Product Change Notice (PCN)

Subject: Carrier Tape dimension change for the listed Renesas WLCSP Packaged Products

Publication Date: 10/1/2020

Appendix A – Comparison of Carrier Tape Dimension

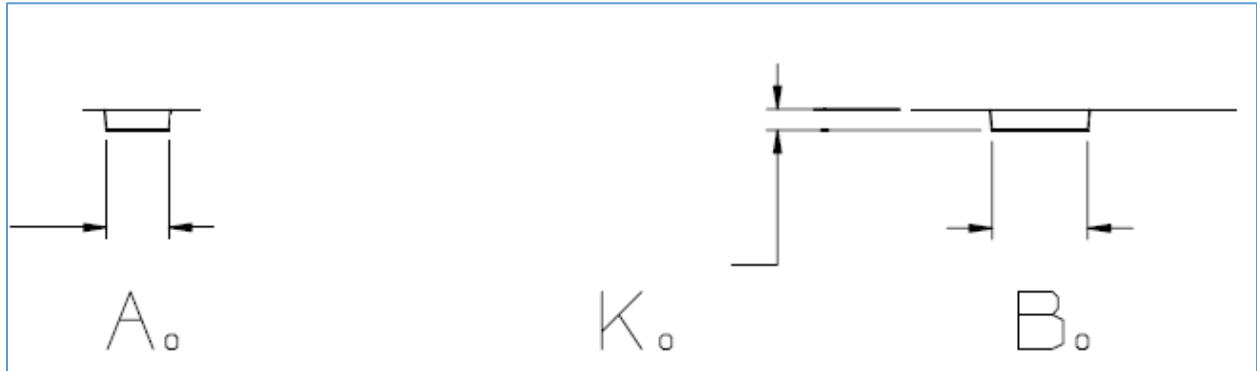
This notice is to inform you that Renesas will begin to use the new Carrier Tape for tape and reel packing of the listed Renesas WLCSP (Wafer Level Chip Scale Package) packaged products. The changes are not expected to affect the automated pick and place equipment used for board mount assembly operations. The differences are outlined in Appendix A.

Details	Existing Carrier Tape	New Carrier Tape	Summary
Width of pocket, A_o	1.51 ± 0.05 mm	1.50 ± 0.05 mm	Smaller
Length of pocket, B_o	1.51 ± 0.05 mm	1.50 ± 0.05 mm	Smaller
Depth of pocket, K_o	0.77 ± 0.05 mm	0.80 ± 0.05 mm	Larger
